Mulgrave School - East and West Additions
Amendment to Development Permit 16-001 & Proposed Re-zoning
and Development Permit for the Mulgrave Campus Southlands

PREFACE

EAST ADDITION

Based on this decision, proposed amendments to Development Permit 16-001 are reflected in this document. The document maintains the organization and content of the approved DP save for the specific design changes pertaining to the East Addition. The table of contents denotes those pages that have been modified.

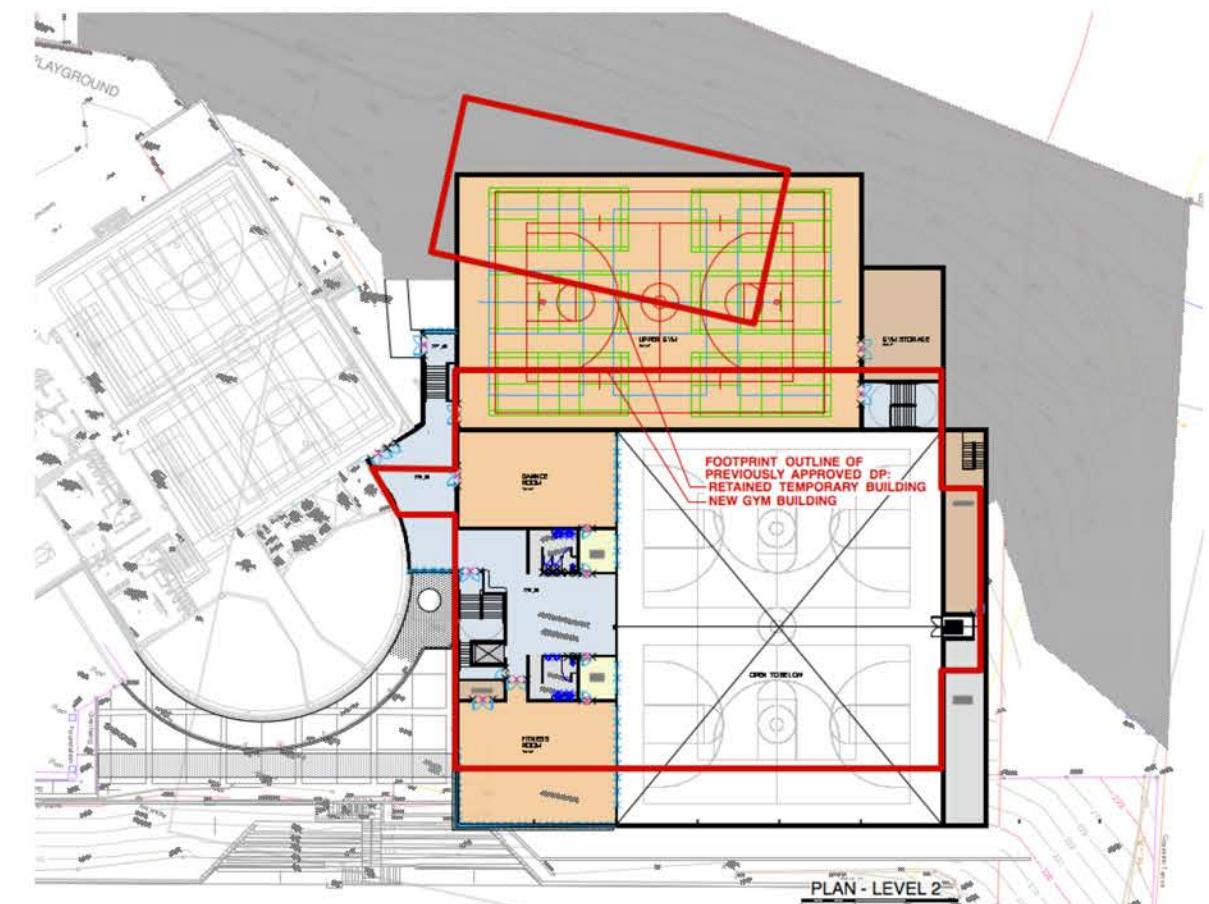
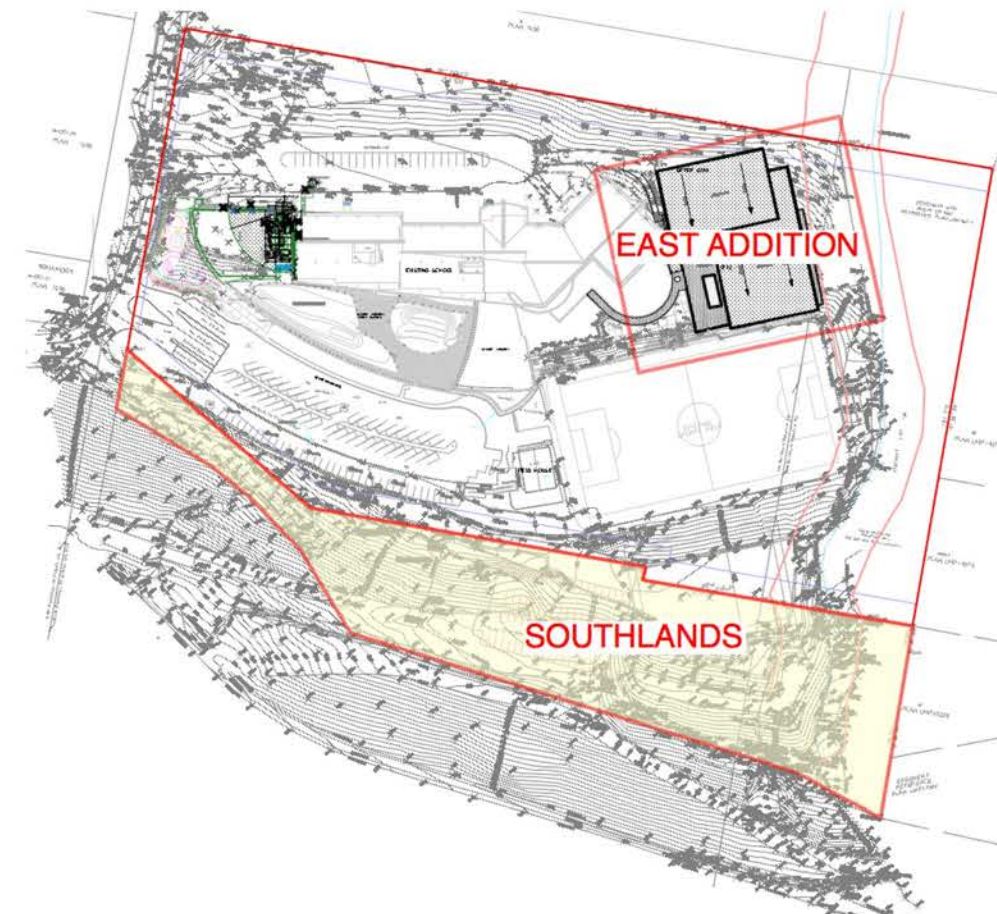
The construction of the East Addition is intended to commence in May 2019 to take advantage of the construction window offered by the school calendar. The current Development Permit contemplates that the last remaining "temporary building" would be retained and dealt with at a later date. Mulgrave School has since decided that, in the interest of facilitating construction and minimizing disruption to the school and its neighbours, the temporary building is better removed and replaced by a permanent structure, and therefore, forms part of the East Addition construction program.

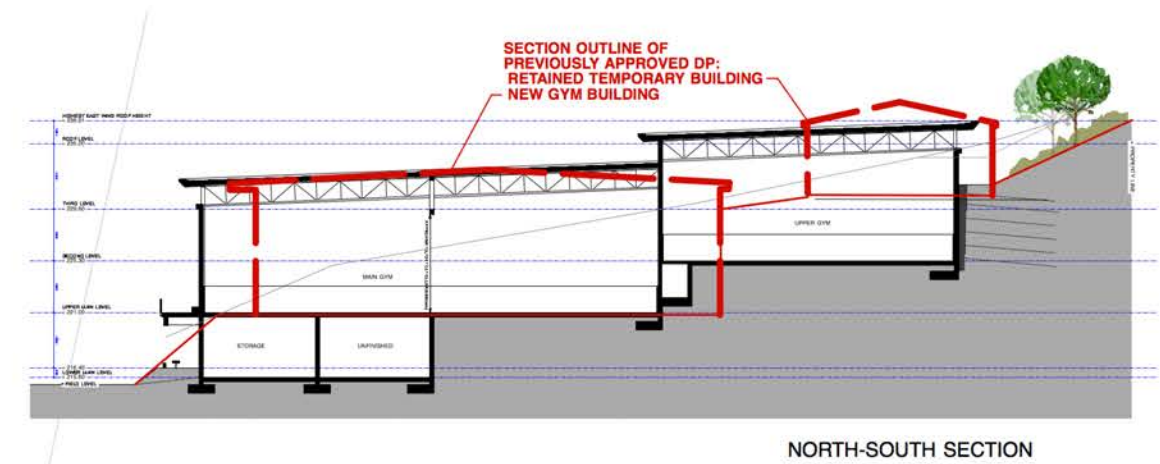
In summary, the proposed design changes to the East Addition comprise the following:

- The design for the proposed new main gym is almost identical in plan to the previous, but the building has been moved 4877mm (16 feet) southward
- With the building closer to the Field it is both desirable and feasible to add a partial lower storey at field level (that is mostly underground)
- The existing temporary building (mini-gym) is to be removed, and using the vacated site footprint, a new Upper Gym development is proposed
- The amended design unifies the architectural treatment of both gym structures, as well as the landscape and technical systems

In addition to the functional benefits, we feel that the amended design results in a more attractive overall development and has no adverse consequences for the neighbours. The figures opposite show:

- the Level 2 Plan for the amended design on which the outline has been superimposed in red of the approved DP East Addition footprint with the retained temporary building – illustrating that the campus development footprint is somewhat increased (from 25.36% to 26.17%) but with no difference to the horizontal view angle presented by the East Addition to neighbours on the slope above

- the amended North South Building Section on which the section outline has been superimposed in red of the approved DP East Addition with the temporary building retained – illustrating that the south part of the roof, over the Main Gym, now a mono-slope, is at virtually the same height as the approved DP; the proposed new Upper Gym roof is somewhat lower than the existing temporary building; both are well below the vertical view angle to the water available to the neighbours on the slope above and the differential effect between the approved and amended DP is insignificant (and marginally positive)
Note: the roof surface treatment remains as per the approved DP; this is a granular-faced roof membrane that will not cause glare
